CITY OF SAN MARCOS

CONSTRUCTION CHANGE ORDER

PROJECT: Sessom Creek Bank Stabilization & Wastewater Replacement - Phase 2
CONTRACT NO.: #224-002
CONTRACTOR: Jerdon Enterprise
ADDRESS: 825 W. Bitters, Suite 203
CITY/STATE/ZIP: San Antonio, TX 78216

Date Prepared: 7/29/2025
Change Order #: 3

**CHANNEL
PLAN AND PROFILE**
1+00 - 5+00
SCALE: 1" = 20' HORZ.
1" = 2' VERT.

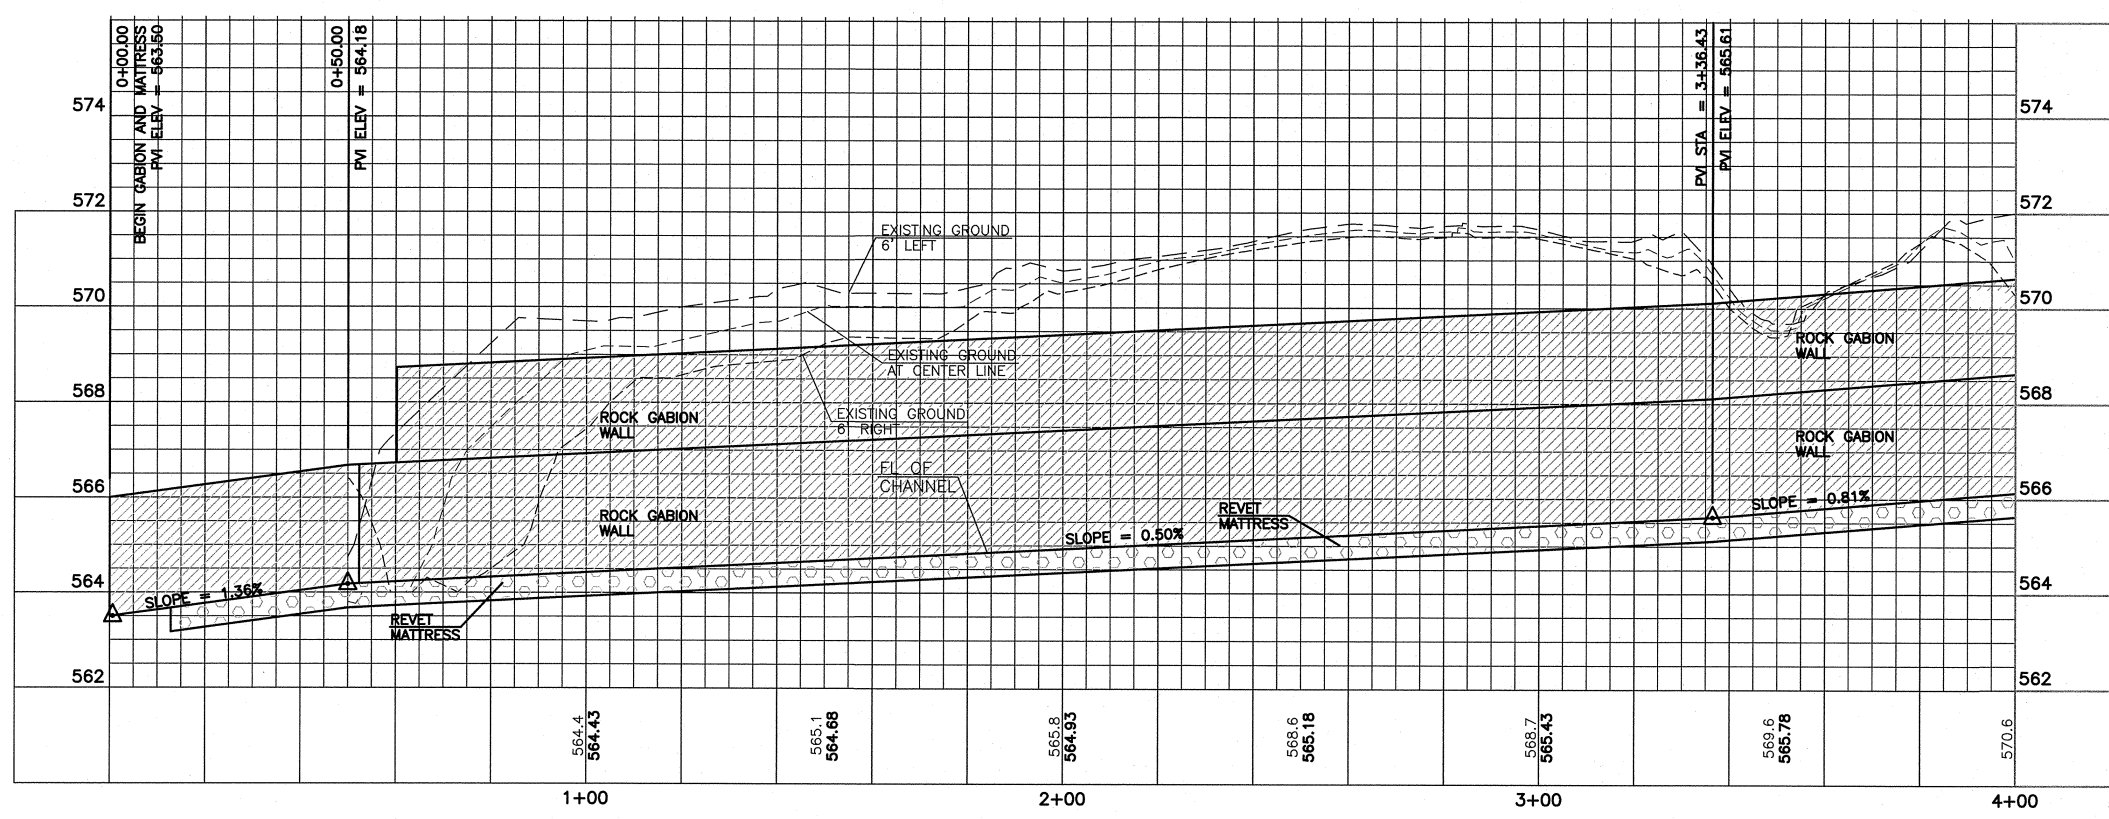
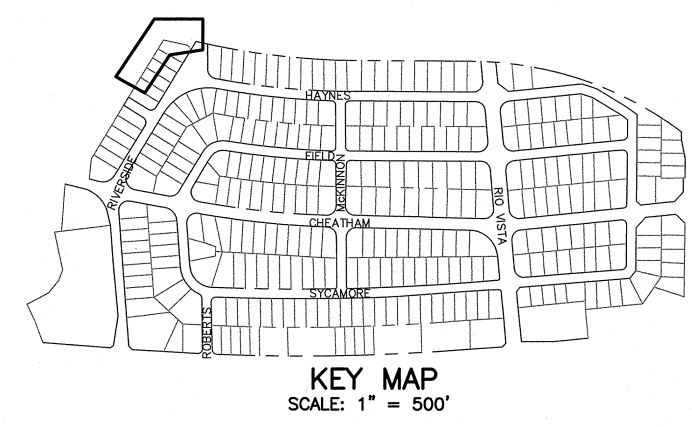
This authorization provides for the following modifications or additions: Rio Vista Outfall Maintenance. Purpose of this Change Order #3 is to fill in a scour hole with rock rip-rap and repair gabion basket chute. Mobilization for CO #3 to be independent of work associated with Sessom Creek Bank Stabilization & Wastewater Replacement-Phase 2 Project. We anticipate 5 weeks to complete the project following the procurement of Gabion Basket and Mattress materials. Our proposal is contingent upon an agreement established with the home owner of 220 Riverside Drive for the job site access.

In response to your request, Jerdon Enterprise proposes to install 21'-0" of Gabion Dissipators, one 12' x 6' x 3' Pie Shaped Gabion, extend 52'-0" of Gabion, Stack 88'-0" of Gabion, install 360 sqft of Gabion Mattress per Rio Vista Terrace plan sheet CH-1 and Item 594S. The work will also include the Repair Scour Damages, Install 6" – 12" Rock Armor for Embankment, Stabilized Construction Entrance, and coordinate Site Access at 220 Riverside Drive for the lump sum price of \$115,949.13.
